**Florida
Power**
CORPORATION

Subject: Crystal River Unit No. 3
Docket No. 50-302
Operating License DPR-72
NRC Letter Dated February 29, 1980, Requesting
Additional Information on Containment Purge
and Vent System

FLORIDA POWER CORPORATION RESPONSE TO NUCLEAR REGULATORY COMMISSION
QUESTIONS ON CONTAINMENT PURGE AND VENT SYSTEM

FIGURE 1

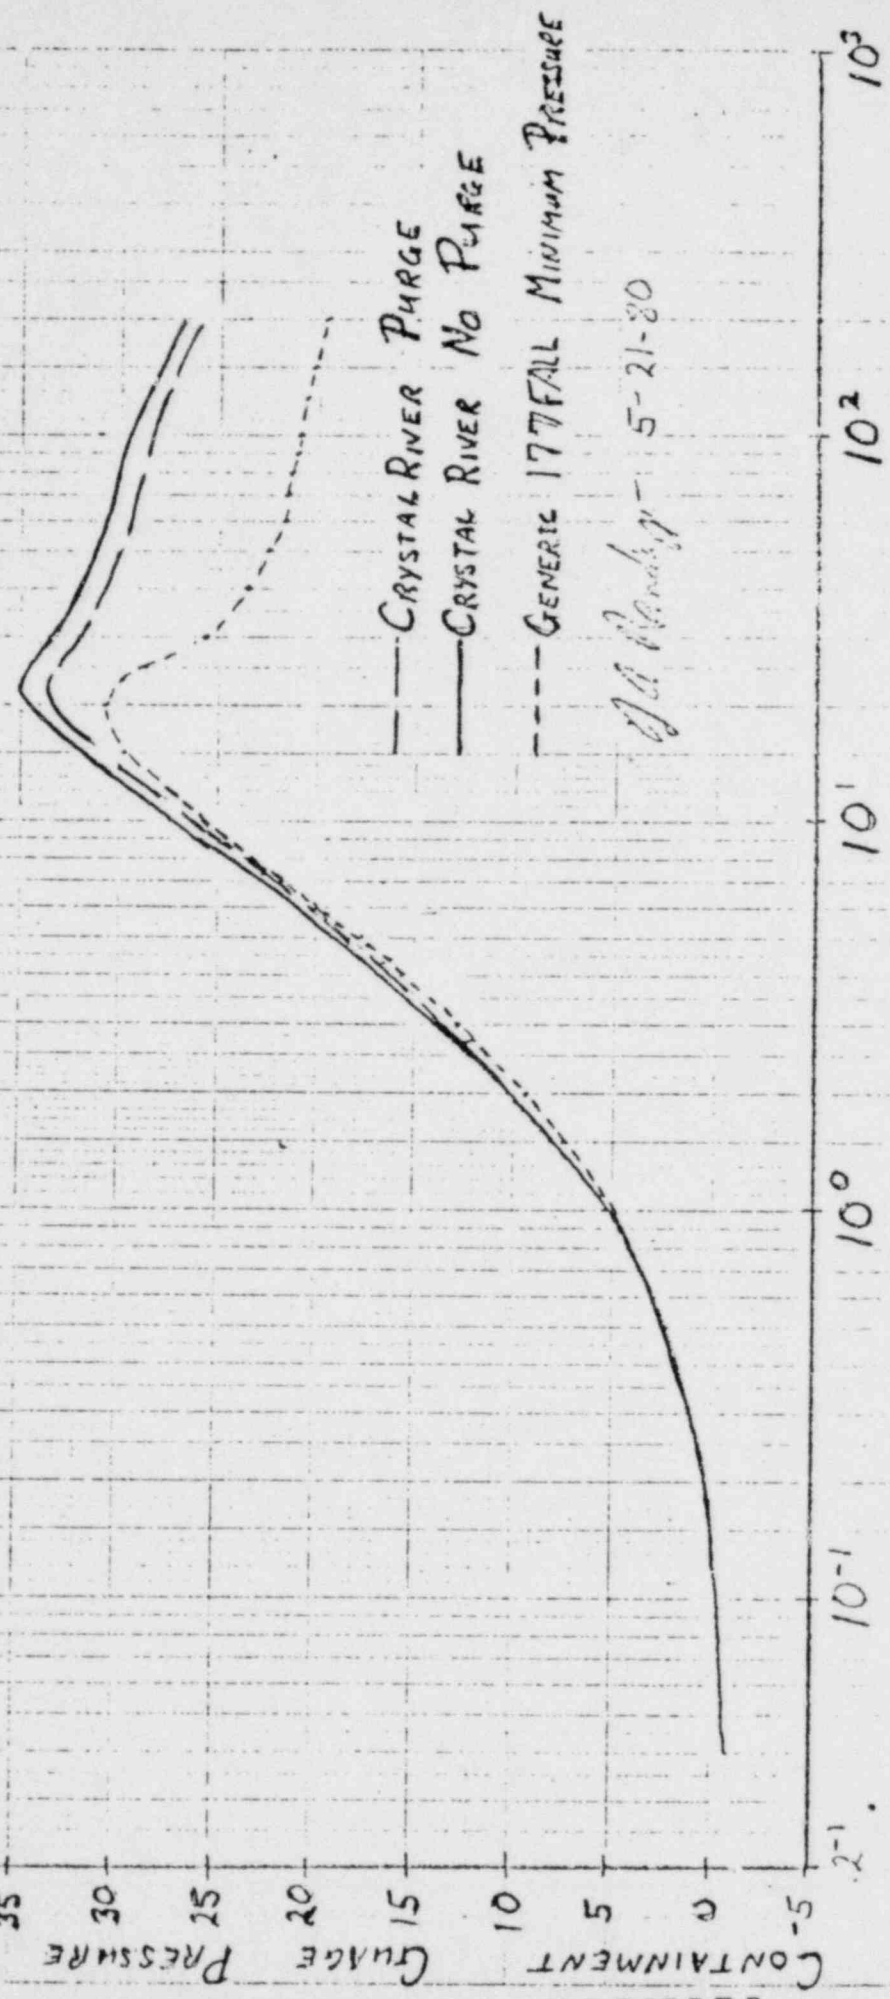
Provide an analysis of the reduction in the containment pressure resulting from the partial loss of containment atmosphere during the accident for ECCS backpressure determination.

The results of the CONTEMPT evaluation is depicted on Figure 1. As shown, the influence of the purge system is to reduce the containment pressure by 1.5 psig. However, even with the purge system assumed operational at the start of the event, the resultant containment pressure is still higher than the value obtained from the generic 177-FA lowered-loop containment pressure evaluation used for demonstrating ECCS conformance to 10 CFR 50.46.
